Kansas Department of Agriculture  
 Division of Water Resources  
**CHANGE: P/U WORKSHEET**

**DATE:** October 19, 2016  
**RE:** Water Right  
File Nos. 1,062; 8,809-D1;  
12,819; 18,011; 35,530 and  
35,531

**APPROVAL OF APPLICATION  
FOR  
CHANGE IN PLACE OF USE AND  
ORDER MODIFYING THE ADDITIONAL LIMITATION  
ON THE AUTHORIZED QUANTITY  
WATER RIGHT  
FILE NO. 18,011**

## GMD3 Change Review

# 1062, 8809 D1, 12819, 18011

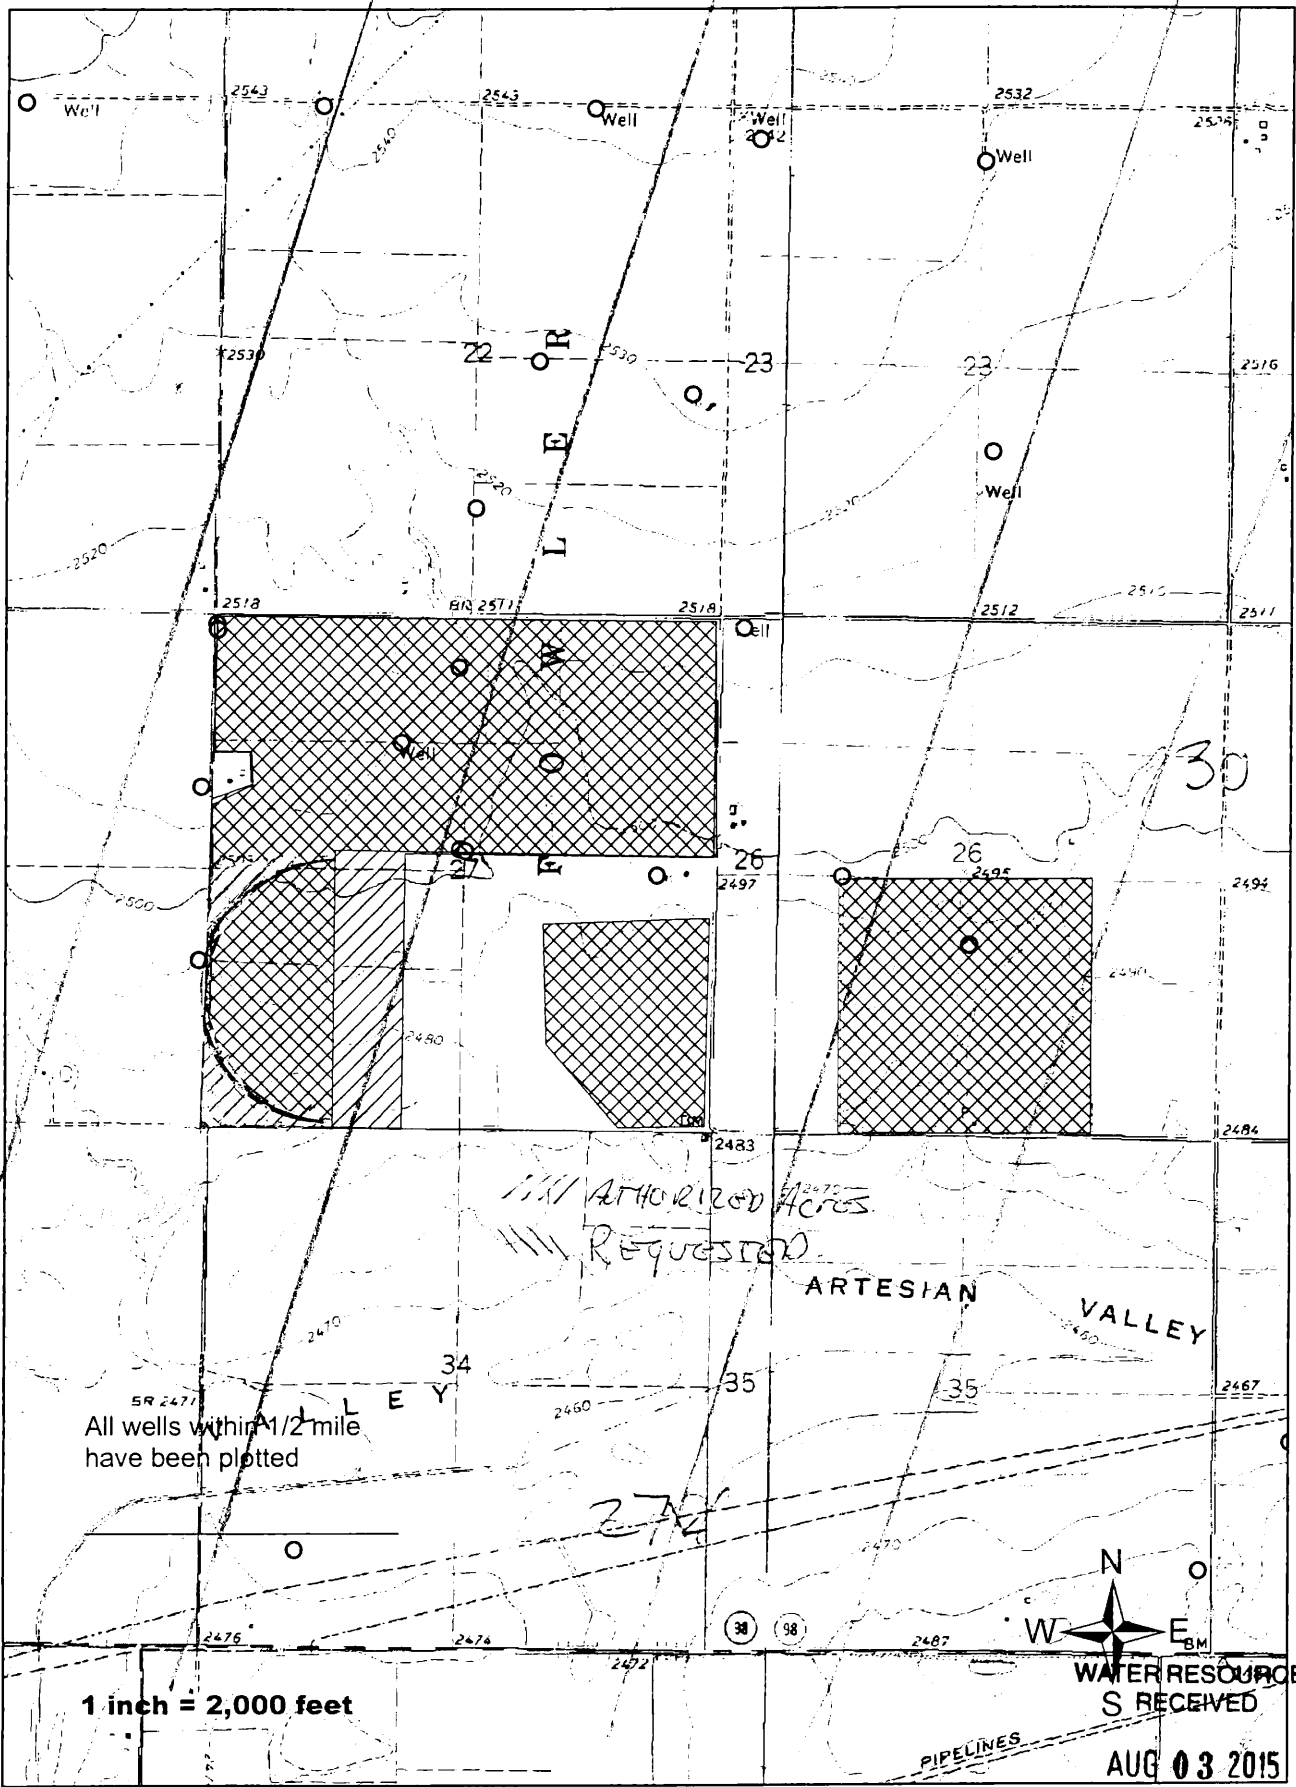
\* See Revised Proposed PU Map  
Received 1/15/16

All wells within 1/2 mile  
have been plotted

File No(s). 1062, 8809D1, 12819, 18011, 35530 & 35531; Fowler Feeders

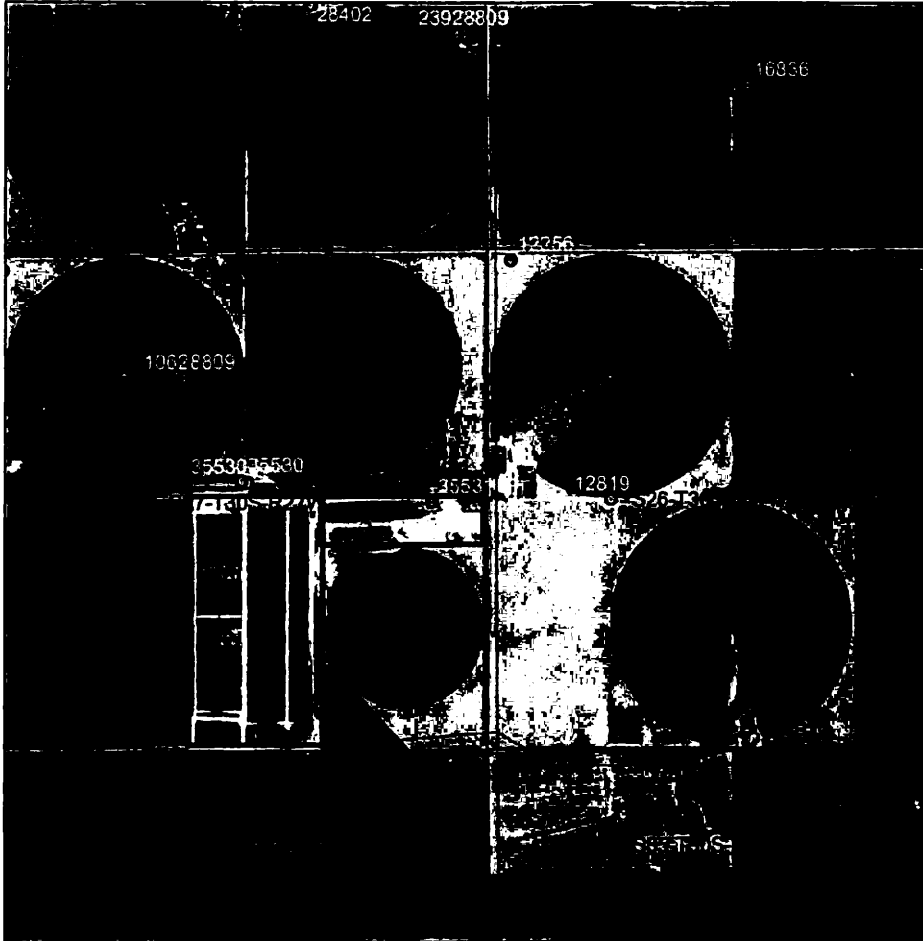
Red outline is current PU for STK watering and the solid red is new area proposed for expansion. This is on the applications filed for WRs 8809D1 STK, 35530 & 35531. A change in place of use was made for WRs 1062, 8809D1 IRR, 12819 & 18011. The changes will still completely overlap place of use for all WRs, but had to be adjusted for the partial change in Use Made of Water, the feedlot expansion and to better show the actual place of use.

Final Recommendation: The applications to change place of use meet the criteria under KAR 5-5-11 and we recommend approval.

The change under 8809D1 requires a waiver to spacing to neighboring wells. This existing wells is not going to be able to utilize the full depth of the well due to casing failure and the applicant state that it is intended to only be used during peak demand like in summer in order to keep feedlot system working properly. Staff and Board therefore recommend a waiver and approval of the application.

# Proposed Move and 1 Mile Circle for WR Nos 1062 & 8809 D1

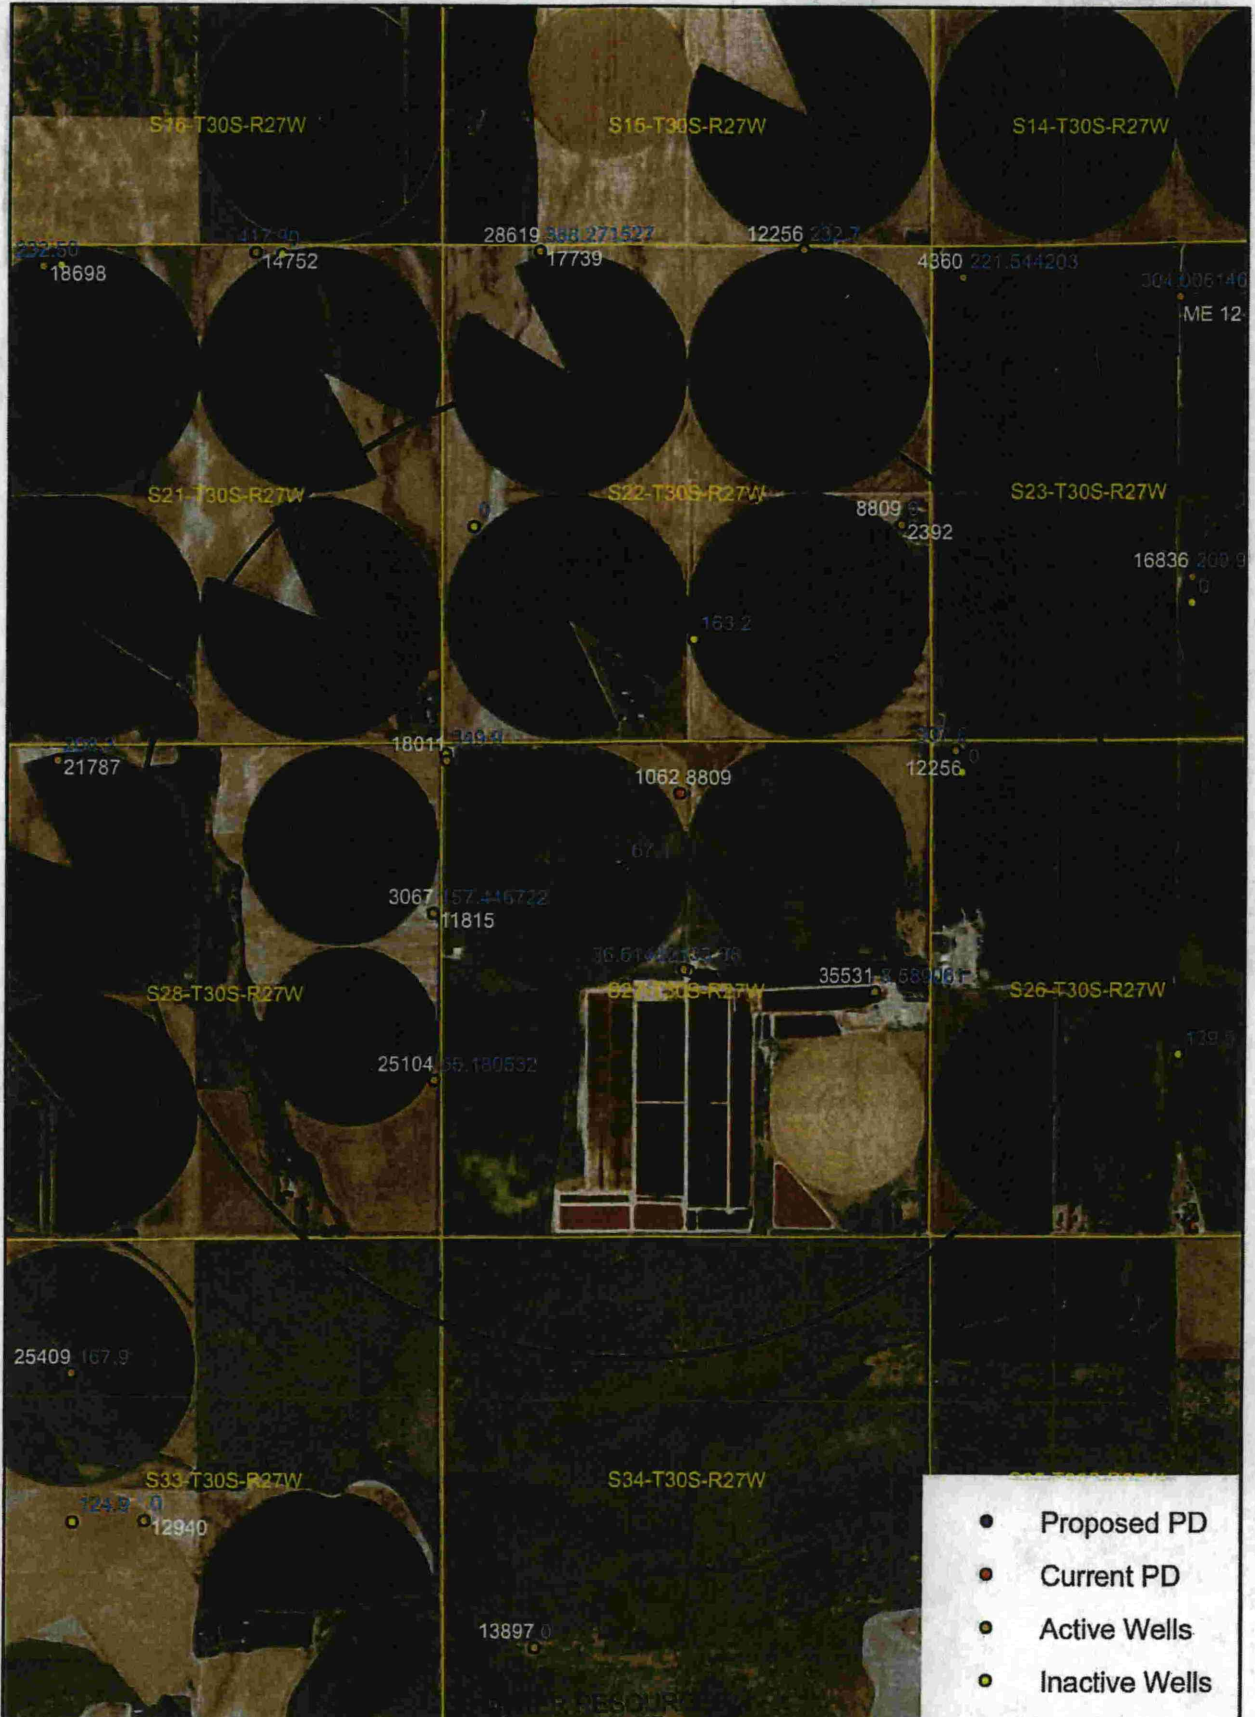
The reason we have submitted this application for approval to change the point of diversion is because the casing on the original well started to cave in, so we put in a new well. Now, we would like to go back to the original well and put in a smaller casing which would allow us to use it in an emergency situation to pump water to our cattle.

In 2015 we used 20 acres of our farm ground to expanded our feed yard. Upon expansion we added two 25,000 Gallon water tanks and our intention is to plumb this well into that system. Our plans are to set this up to pump 50 gallons per minute average over a years' time, to be used in an emergency situation and summer time The original wells at the yard pump 200-220 gpm and this amount keeps us tight in the summer time, the addition of this well would allow us a little more capacity. Essentially we are taking water away from ourselves and would be willing to give up water rights on the land to convert it to stock water.
